SOUTH CAROLINA STATE HIGHWAY DEPARTMENT

FINAL CONSTRUCTION PLANS

BRIDGE

OVER Black River & Eleven Culverts on U.S. Rt. 301 (2 Culv. Deleted)

FED. ROAD DIV. NO.	STATE	COUNTY	DOCKET NO.	PROJECT NO.	ROUTE NO.	SHEET NO.	TOTAL SHEETS
3	S.C.	Clarendon 1	4-361	F-3306(6)	301	39	54

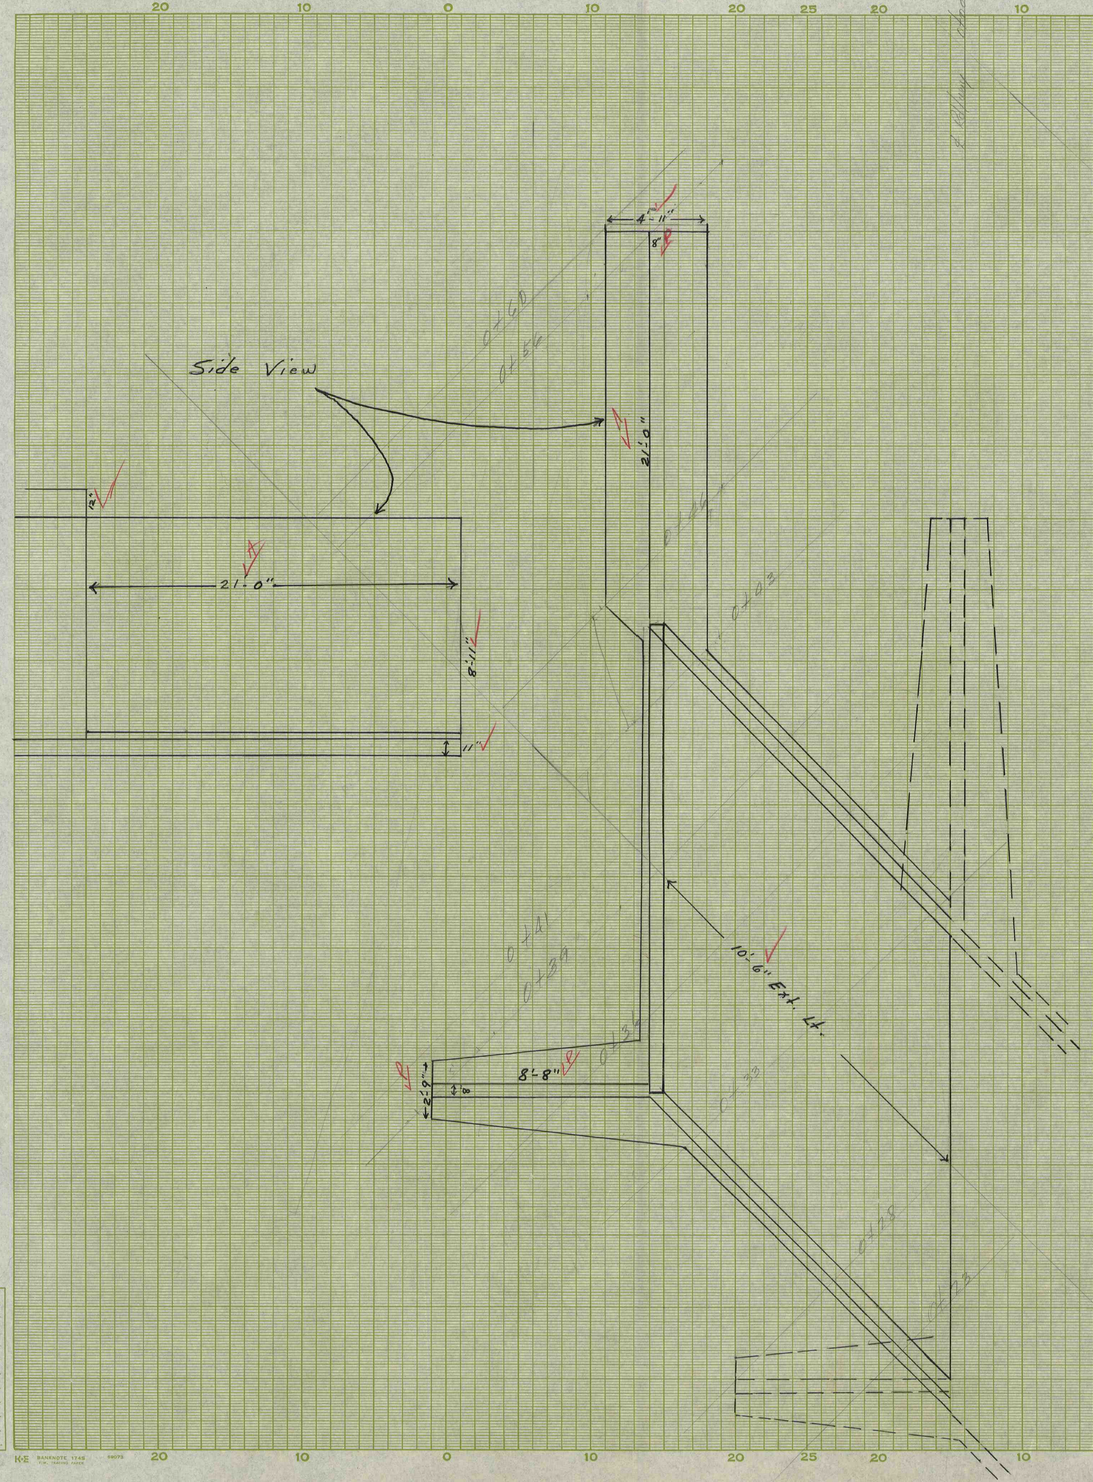
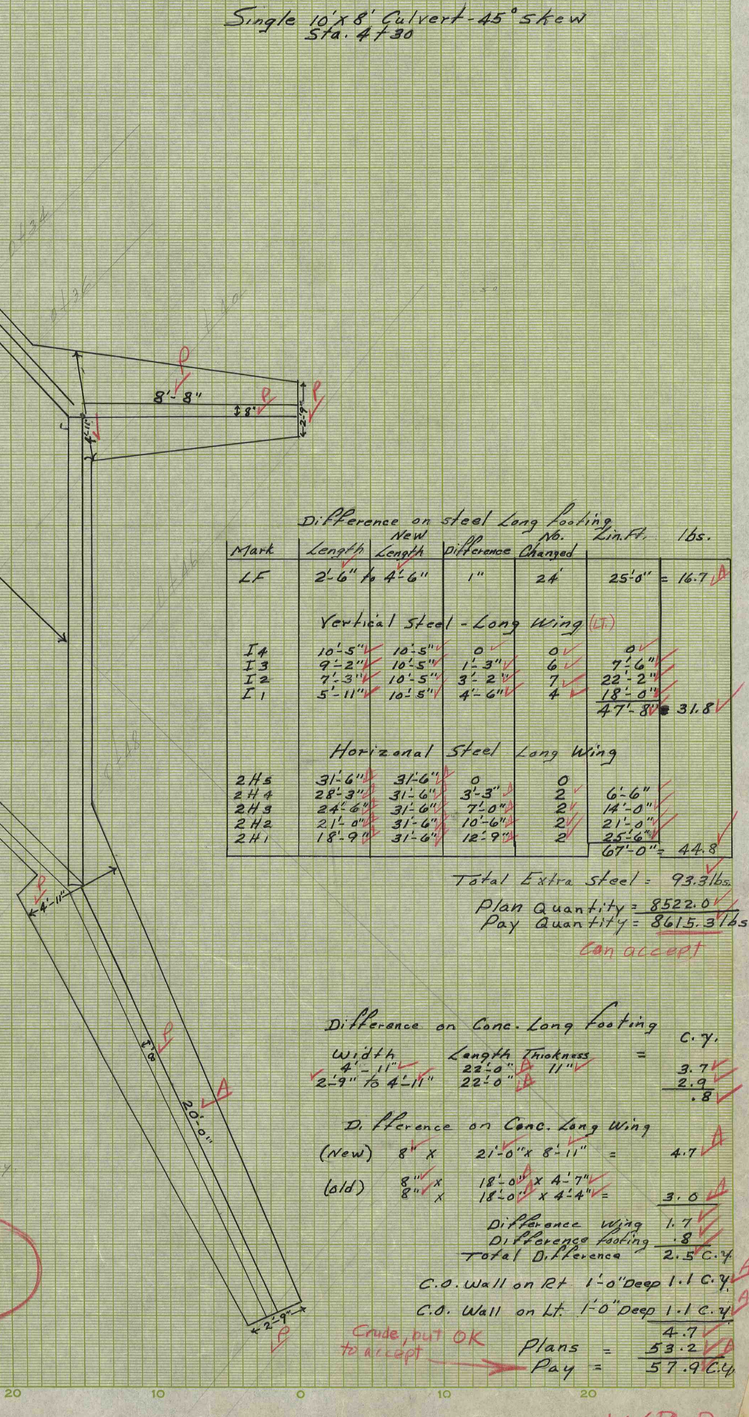
Difference on steel Long footing

Mark	Length	New Length	Difference	No. Changed	Lin. Ft.	lbs.
LF	2'-6" to 4'-6"		1"	24'	25'-0"	= 16.7
	Vertical steel - Long Wing (LT)					
I4	10'-5"	10'-5"	0	0	0	
I3	9'-2"	10'-5"	1'-3"	6	7'-6"	
I2	7'-3"	10'-5"	3'-2"	7	22'-2"	
I1	5'-11"	10'-5"	4'-6"	4	18'-0"	
					47'-8"	= 31.8
	Horizontal steel Long Wing					
2H5	31'-6"	31'-6"	0	0		
2H4	28'-3"	31'-6"	3'-3"	2	6'-6"	
2H3	24'-6"	31'-6"	7'-0"	2	14'-0"	
2H2	21'-0"	31'-6"	10'-6"	2	21'-0"	
2H1	18'-9"	31'-6"	12'-9"	2	25'-6"	
					67'-0"	= 44.8

Single 6'x4' Culvert - 30° Skew
Sta. 81+00

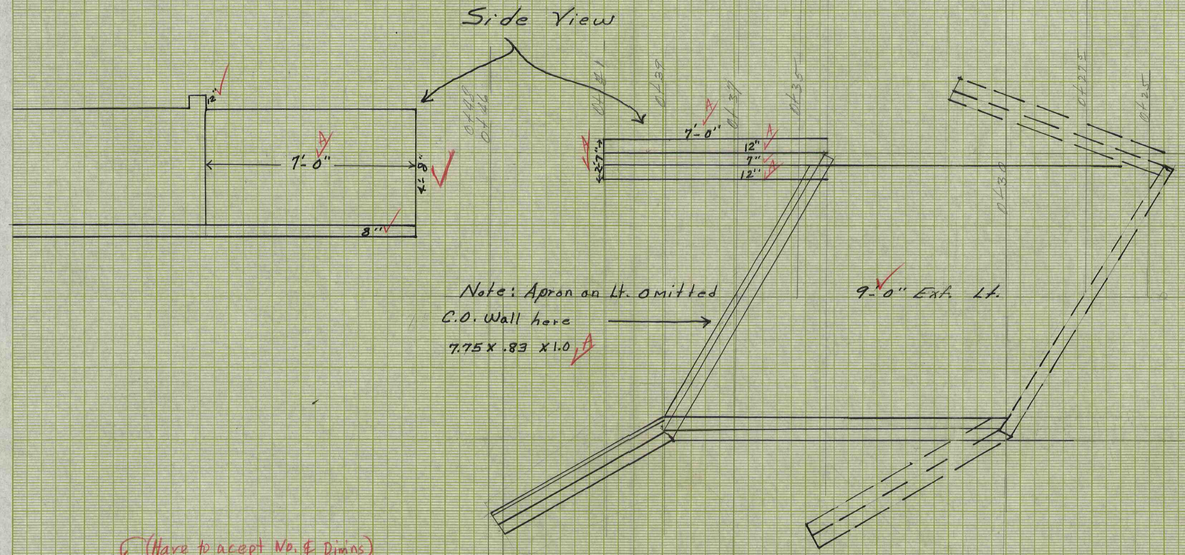
(Have to accept No. & Dimns)

Single 6'x5' Culvert
Sta. 125+93

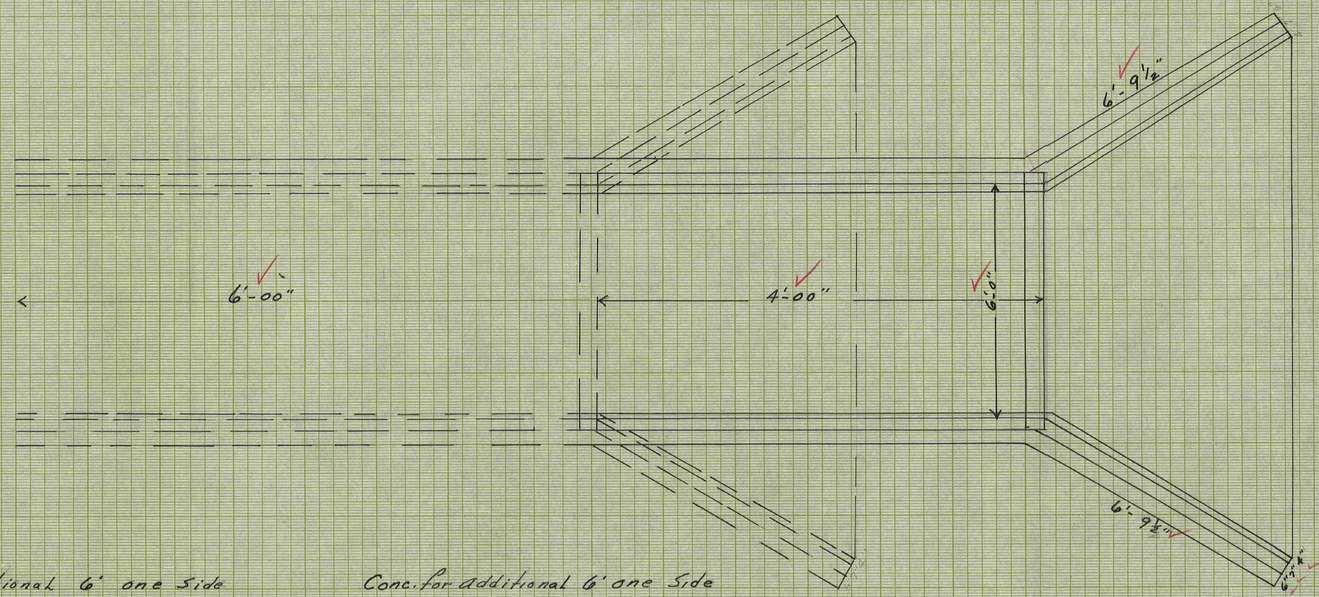
Note: This Culvert was set up to be Extended 4'-0" Rt & 4'-00" Lt. The existing walls were Constructed out of Concrete Blocks for a distance of 6'-0" Rt & 6'-0" Lt. This portion was Removed, making the overall extension 10'-0" Rt. & 10'-0" Lt.

Steel for additional 6' one Side
